**ZILKER NEIGHBORHOOD ASSOCIATION COMMENTS  
TO THE PLANNING COMMISSION HEARING (27 AUG 2019)  
ON 211 SOUTH LAMAR PUD REZONING**

- Property Lines
- Ordinance Description of Location 96' Maximum Height for First Building Block
- Ordinance Description of Location 86' Maximum Height for Second Building Block (dashed line indicates the location is indeterminate)

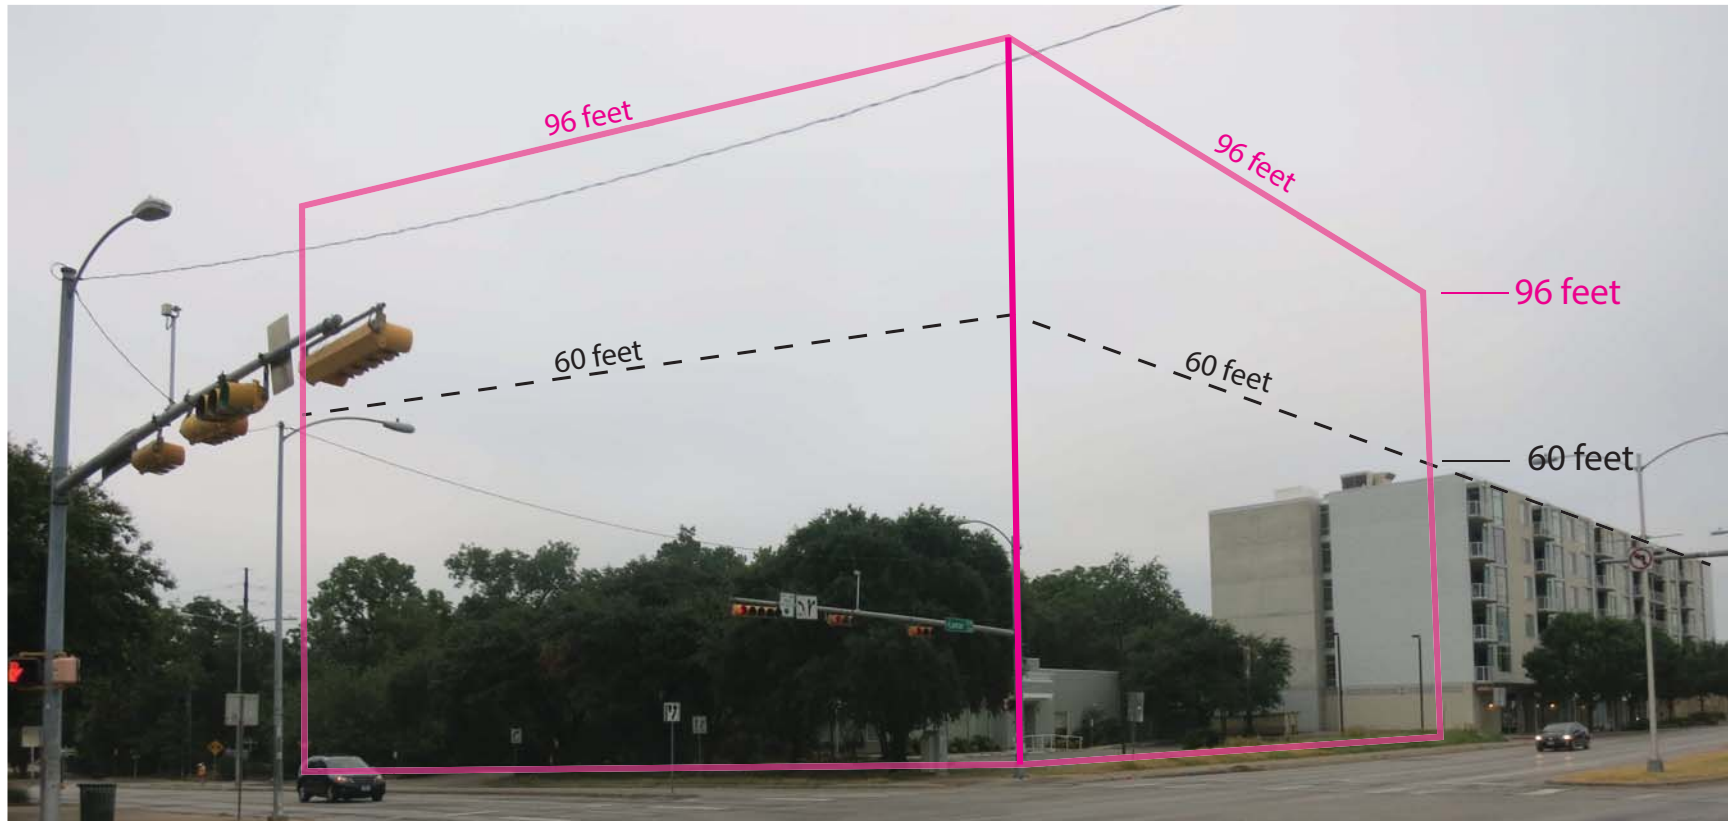
Presumably the reference to "Project's southern property line along Lee Barton Drive" refers to east-west property line between the hotel project and the Paggi House which is more or less perpendicular to Lee Barton Drive (rather than "along" it). The language seems to propose two building blocks, but the second building block (86' in height) appears to be completely contained within the first building block (96' in height) as shown in Exhibit 1, so it is unclear whether there will even be a second building block. The entire project could be 96' high as we read the language.

View from Pfluger Pedestrian Bridge  
(dashed red line shows 96' height at edge of The Bridges; solid red line shows approximate location of hotel)

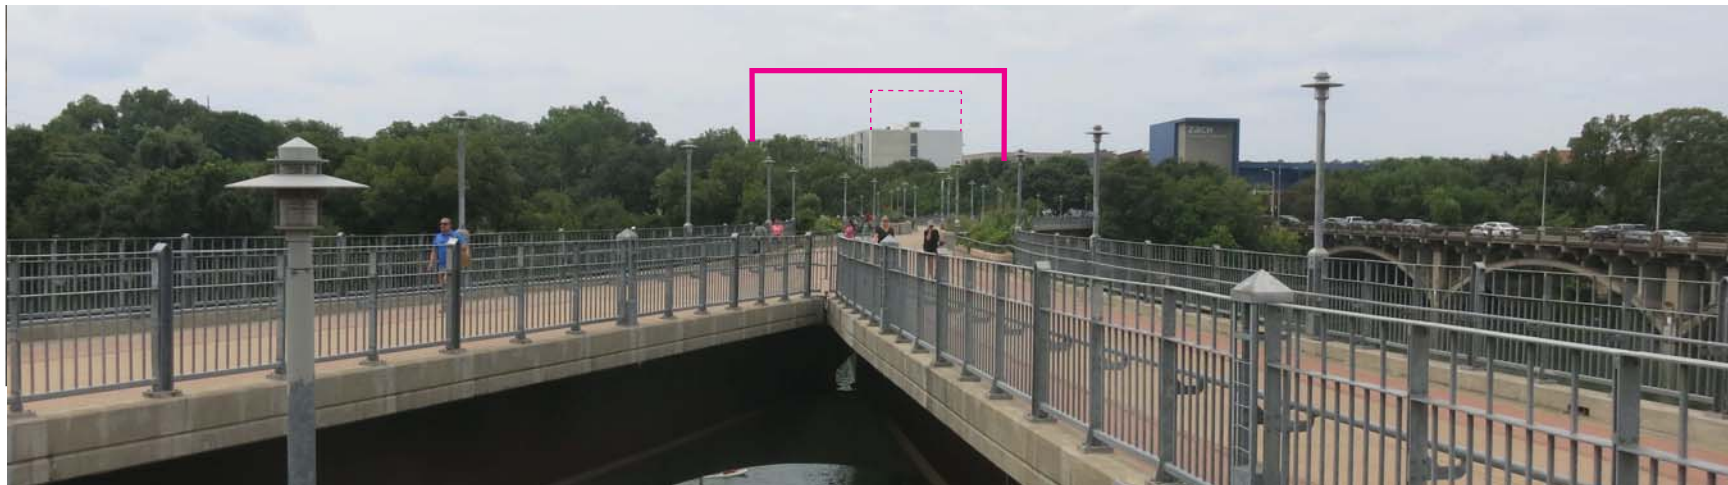
This building will dominate the view along Butler Shores and the southern view from the Pfluger Pedestrian Bridge as one crosses Lady Bird Lake (see Exhibit 2). It will loom over the Butler Pitch and Putt Golf Course where the view still feels like a park setting, but it will not feel like a park setting when a 96-foot glass building looms over the northern end of the course (see current views from Butler Pitch and Putt in Exhibit 3).

Most of the sky behind the trees along Lee Barton in this photo will be replaced by a view of the hotel

Most of the sky on the left three-quarters of this photo will be replaced by a view of the hotel

Hotel (new proposed project)

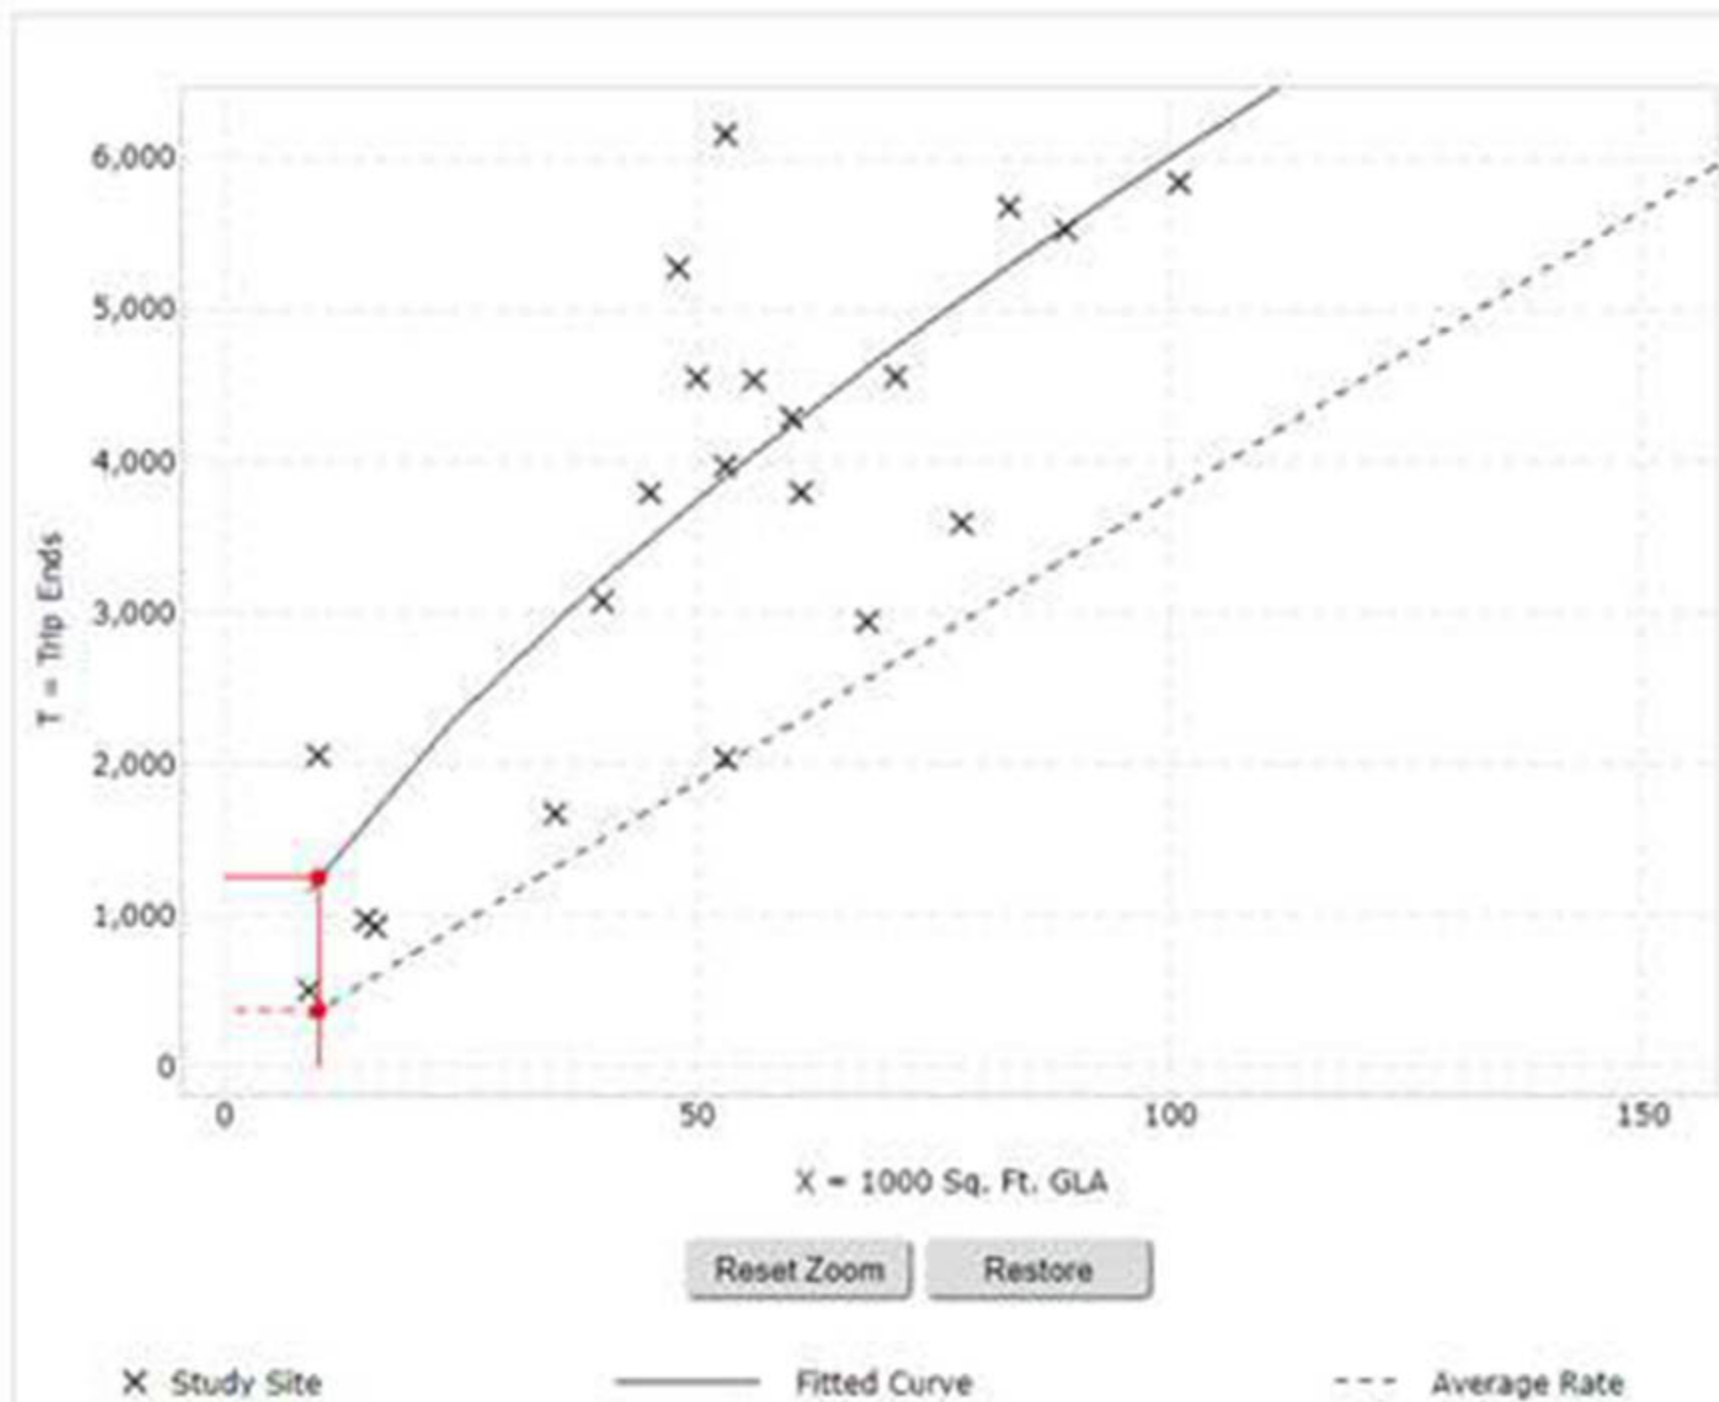
Land Development Code § 25-2-723(3) for the Butler Shores Subdistrict of the Waterfront Overlay states the following: "Except for transparent glass required by this subsection, natural building materials are required for an exterior surface visible from park land adjacent to Town Lake." Except for the first floor which is required to have transparent glass, the exterior surfaces of the remainder of the building visible from the park land do not appear to be made of natural building materials. They appear to be primarily glass with non-natural framing. It is not clear how this meets the design requirements of the Waterfront Overlay. The exterior surfaces of the original project appeared to be constructed of mostly natural building materials (see Exhibit 4 for a comparison).
